SERVICE NOTE

EFFECT: SUBROC-3D

NUMBER: 001

There have been some errors identified in the SUBROC-3D Owner's Manual (P/N 420-0822). Please correct your documentation as follows:

An error has been found on page 140 of your SUBROC-3D Owner's Manual (P/N 420-0822), CPU Board sheet 2, Drawing No. 834-0358, Zone C-3. Please correct your schematic as indicated:

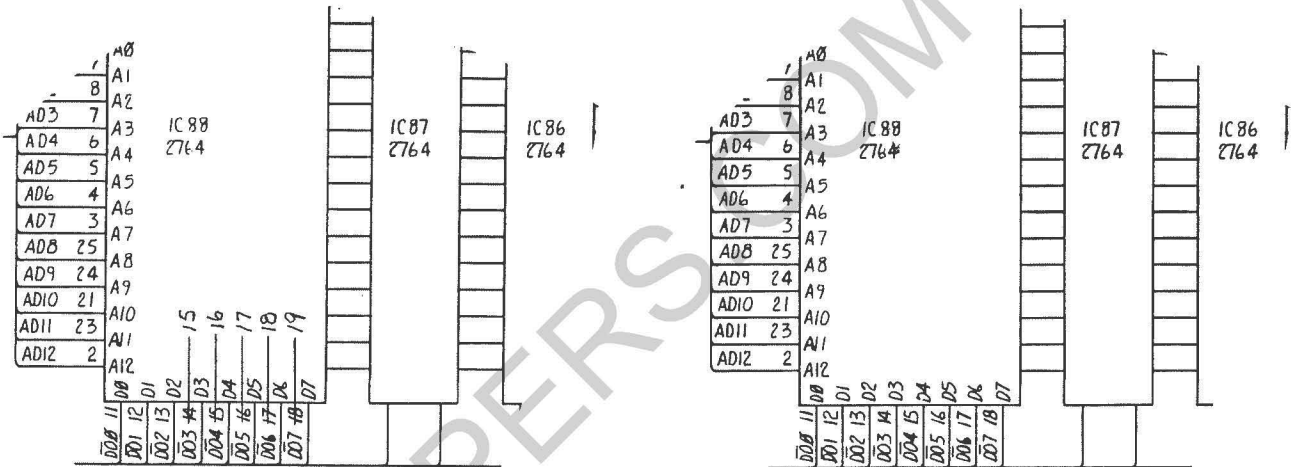
WAS:

IS:
